**City of
Richmond**

Report to Development Permit Panel

File: DP 16-728670

Re: **Application by Anwer Kamal for a Development Permit at 6571 No. 4 Road
(formerly 6571/6573 No. 4 Road)**

PLAN 21B

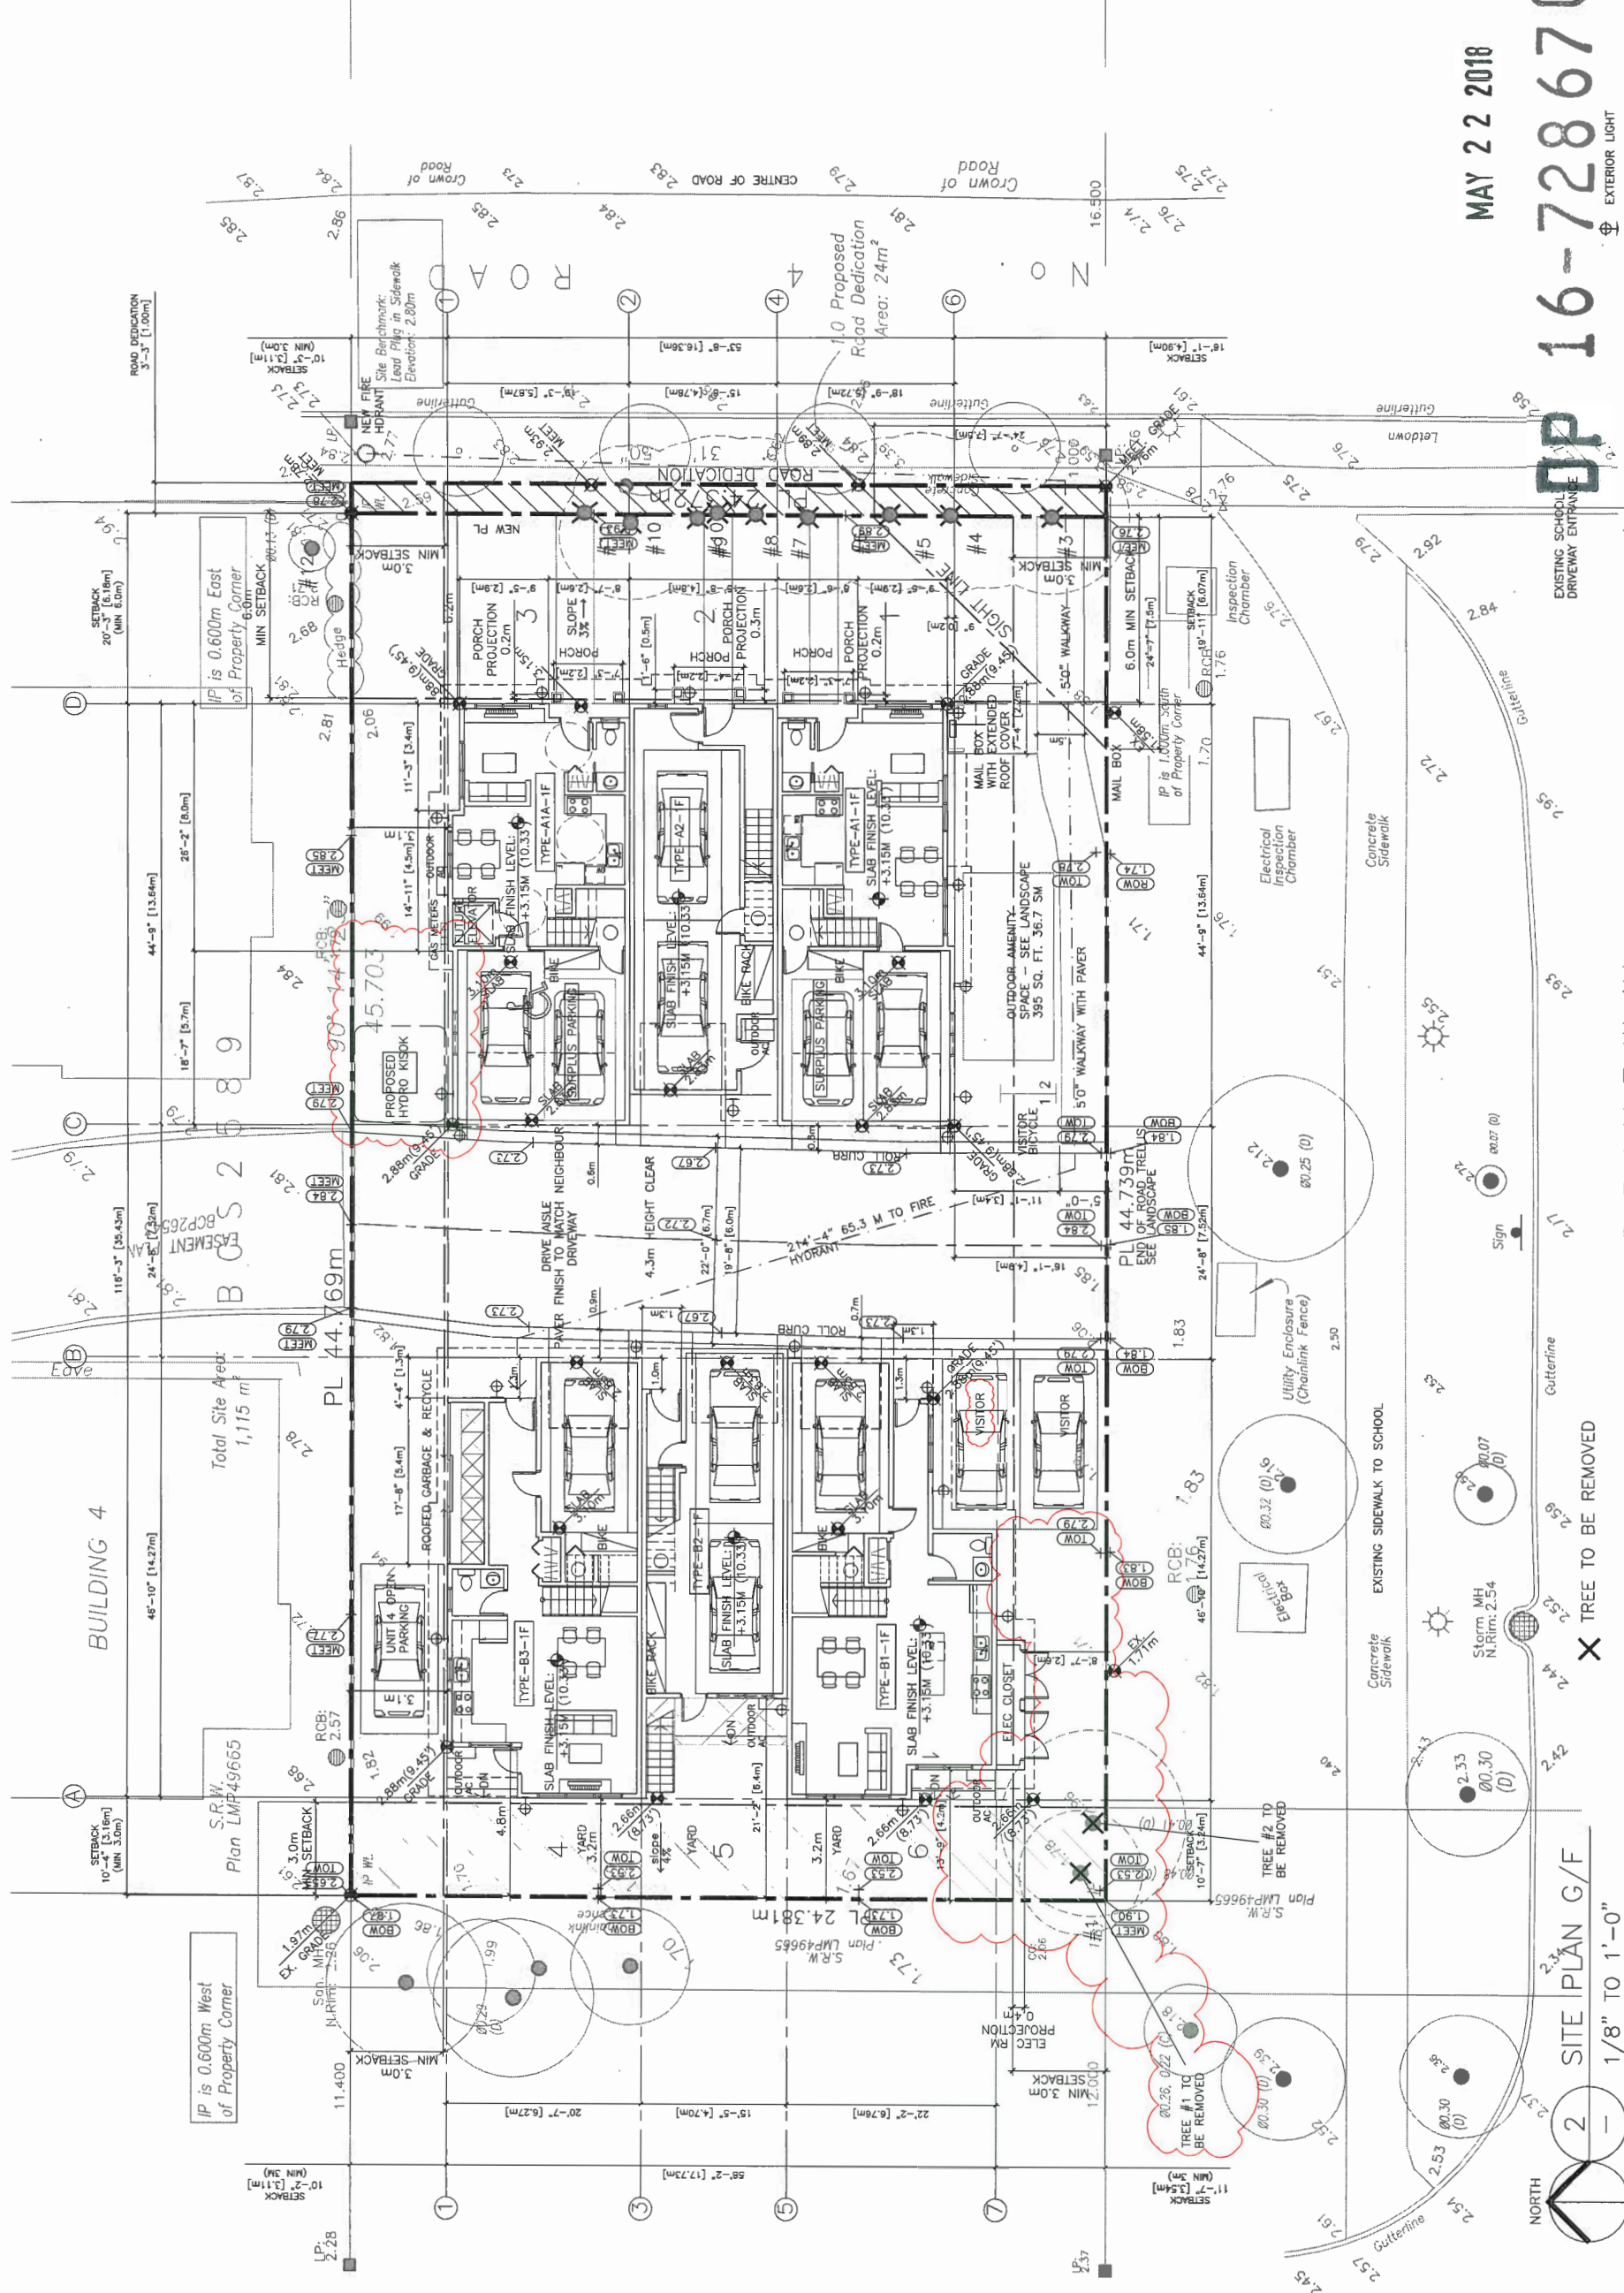
- Change of site grade at the southwest corner of the site (i.e., where the tree well required to protect the 42 cm calliper Western Red Cedar tree was located) to match the proposed site grade of the adjacent yard areas, and integrate this space into the adjacent private yard space and the adjacent common area.

- Removal of one surface parking stall adjacent to the northwest corner of the internal drive aisle to allow the relocation of the hydro kiosk, as per BC Hydro's request. The proposed numbers of residential and visitor parking spaces are still in compliance with the bylaw. Please refer to the attached Development Application Data Sheet (Attachment C) for a comparison of the proposed development data with the relevant bylaw requirements.

- Planting of one additional tree at the original hydro kiosk location along the south property line.
- Minor amendments to the window openings to meet Building Code requirements.

All proposed changes to the Development Permit application are highlighted with red clouds on the attached Development Permit drawings.

Tree Removal & Retention Plan, Scale 1/16 = 1'

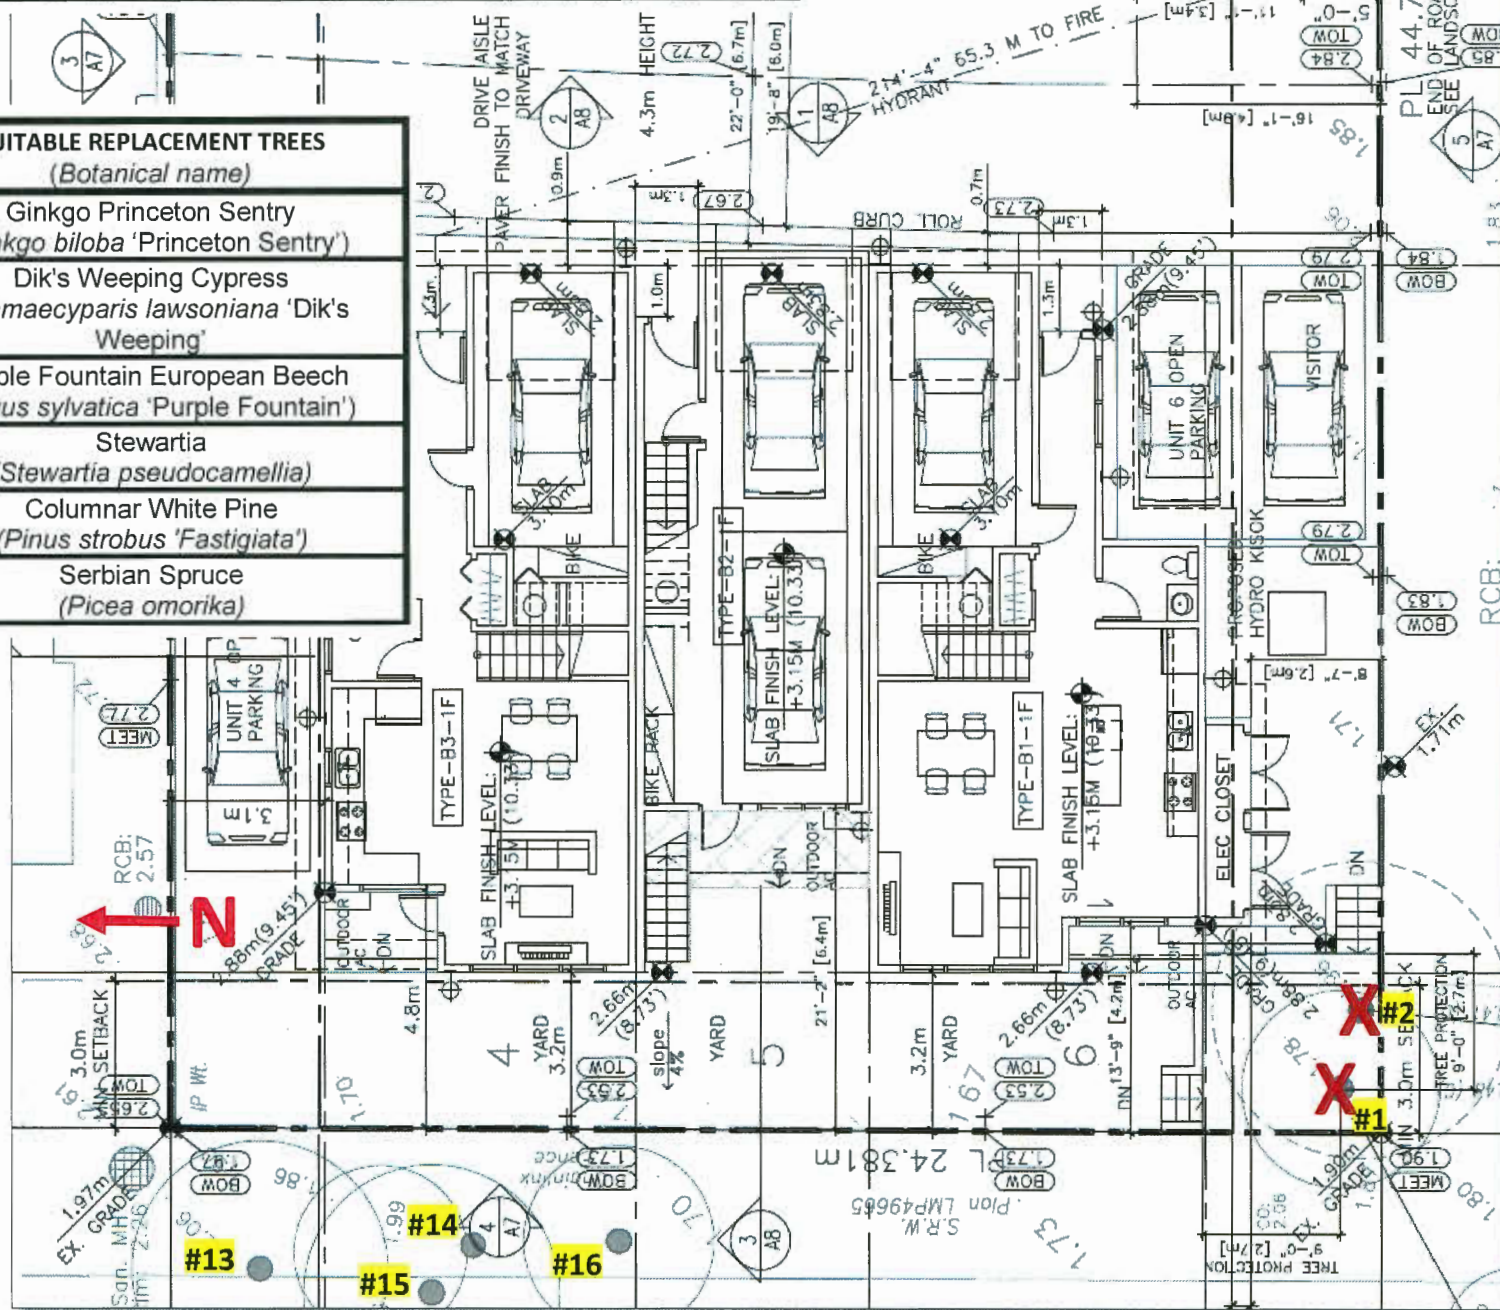
The Development Permit endorsed by Development Permit Panel on September 13, 2017 includes the protection and retention of a 42 cm calliper Western Red Cedar tree located at the southwest corner of the site. However, during the site preparation stage, prior to final adoption of the rezoning bylaw and issuance of the Development Permit, Tree Group staff noticed that the tree protection fencing had been pushed up against the tree and that the protected Western Red Cedar tree is damaged due to preload lock-blocks located approximately 0.3 m from the tree. Both the City’s Tree Preservation Coordinator and the project arborist agreed that the Western Red Cedar tree is dying as a result of preloading within the required tree protection zone; and that this tree should be removed. A report submitted by the project arborist can be found in Attachment B.

- plant a new 40 cm calliper Western Red Cedar tree at the northeast corner of the site;
- upsize the proposed Austrian Black Pine trees from 3.5 m to 4.5 m high;
- increase the pot sizes of shrubs and perennials; and
- upsize the height of the proposed Emerald Green Cedar along the side and rear property lines from 5 ft. to 6 ft.

A new Tree Management Plan and Landscape Plan are attached to the revised Development Permit Drawings.

The applicant is proposing to replace the dying 42 cm calliper Western Red Cedar tree located at the southwest corner of the site with a new 40 cm calliper Western Red Cedar tree at the northeast corner of the site. This proposal has been reviewed and accepted by the City's Tree Preservation Coordinator. As fines have been issued to the owner and the pre-load contractor already, no additional compensation is requested.
